UNITED STATES PATENT AND TRADEMARK OFFICE

APPLICATION NO.	FILING DATE	FIRST NAMED INVENTOR	ATTORNEY DOCKET NO.	CONFIRMATION NO.
10/766,465	01/27/2004	Ling Ma	IR-2444 CIP (2-3869)	3194
2352	7590	11/22/2005	EXAMINER	
OSTROLENK FABER GERB & SOFFEN 1180 AVENUE OF THE AMERICAS NEW YORK, NY 100368403			KIM, SU C	
			ART UNIT	PAPER NUMBER
			2823

Office Action Summary

DETAILED ACTION
REMARK / ARGUMENT

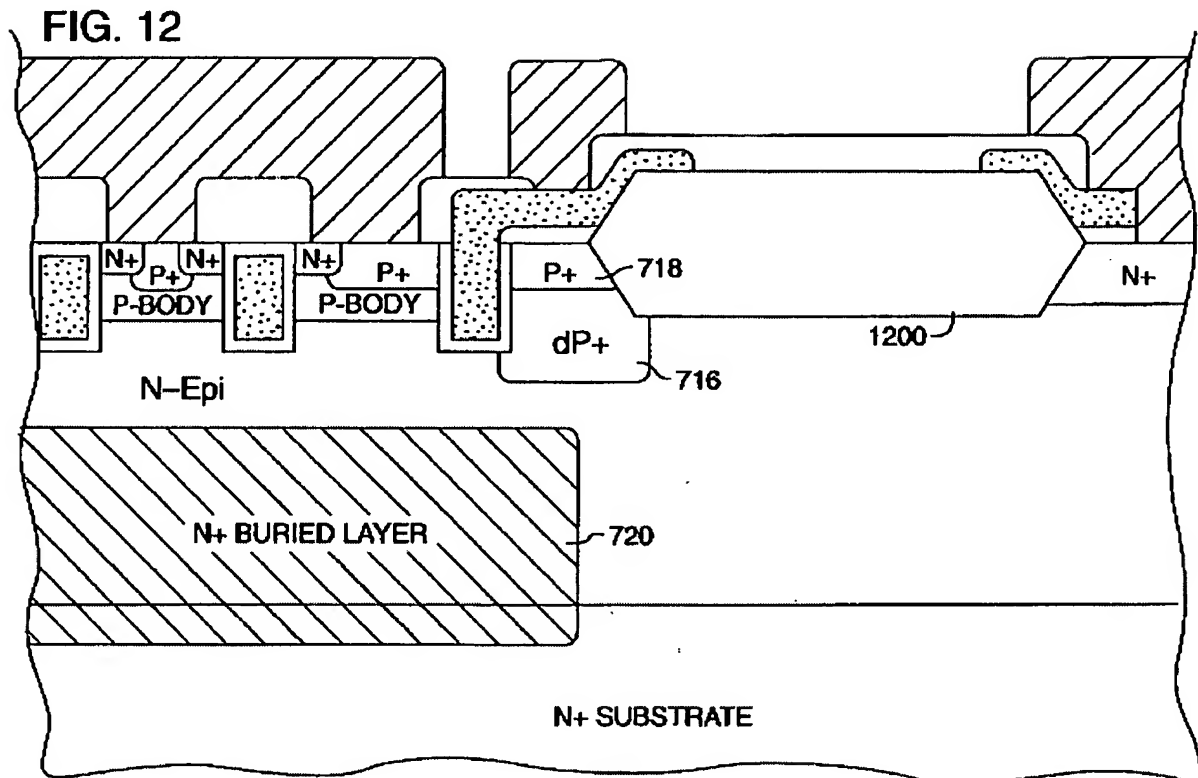
Claims 1, 7, & 8 are rejected under 35 U.S.C. 103(a) as being anticipated by Williams (US 5814858) in view of Zeng (US Pub 2003/0205758).

Williams discloses DC-DC converter as claimed. **See all the FIGS** where Williams teaches the following limitations

an active region (**Fig. 11**) formed in said semiconductor body, said active region including a trench **702** extending through said channel region and a gate structure **702** disposed in said trench which includes a gate oxide layer **1102** (Column 7 lines 29-30) disposed at least on said sidewalls of said trench and a gate electrode **702** disposed adjacent said a gate oxide layer: and

a termination structure(**Fig. 12**), said termination structure including, a termination trench formed in said semiconductor body, and a field oxide layer formed in said termination trench below said major surface (**Fig 12**),

Williams fails to teach a field oxide layer formed in said termination trench below said major surface is thicker than said gate oxide layer. Zeng discloses a field oxide layer formed in said termination trench below said major surface (**Fig. 15 please note the element 340 (Oxide layer) is thicker than the gate oxide layer 40**). In view of Zeng, it would have been obvious to one of ordinary skill in the art to incorporate the process step of Zeng into the Williams because "the power MOSFETs used in power management circuitry can be efficiently turned on and off at low gate drive voltage" (column 1 paragraph[0002] lines 8-10).

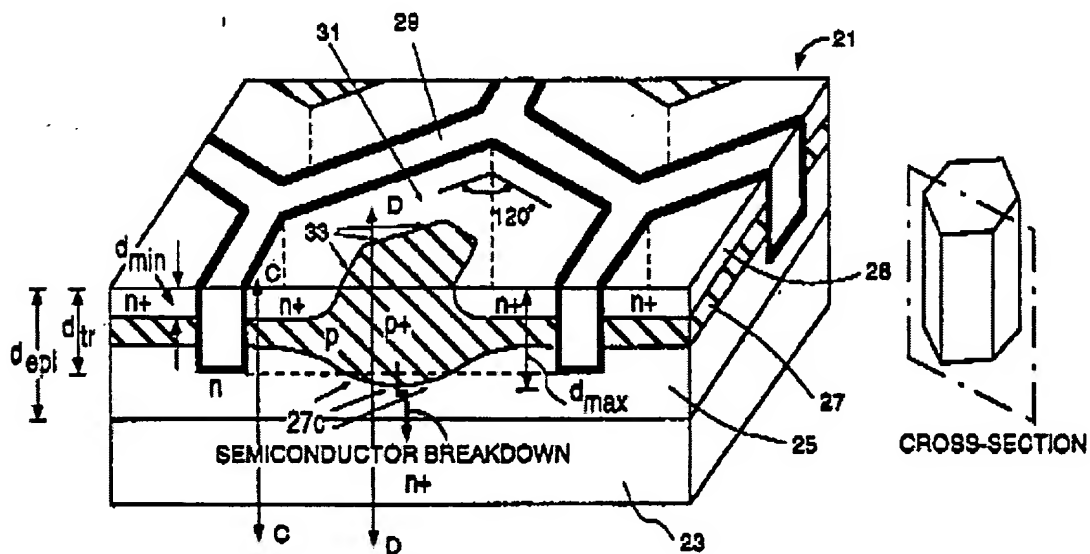
Claims 9-10 are rejected under 35 U.S.C. 103(a) as being anticipated by Williams (US 5814858) in view of Zeng (US Pub 2003/0205758) and further in view of Bulucea et al. (US 5298442)

Bulucea discloses a semiconductor device as claimed. See all the FIGS where Bulucea teaches the following limitations

7. Pertaining claim 9, Williams in view of Zeng fails to teach a semiconductor device according to claim 1, wherein said trench is a cell. Bulucea discloses a semiconductor device according to claim 1, wherein said trench is a cell (**Fig. 8**). In view of Bulucea, it would have been obvious to one of ordinary skill in the art to incorporate the process step of Bulucea into the Williams in view of Zeng because "maximizes the gate dielectric breakdown voltage and also provides position of voltage breakdown initiation to allow use of controlled bulk semiconductor breakdown." (**Column 1 lines 59-61**)

8. Pertaining claim 10, Williams in view of Zeng fails to teach a semiconductor device according to claim 9, wherein said cell is hexagonal. Bulucea discloses the cell is hexagonal. (**Fig. 8**)
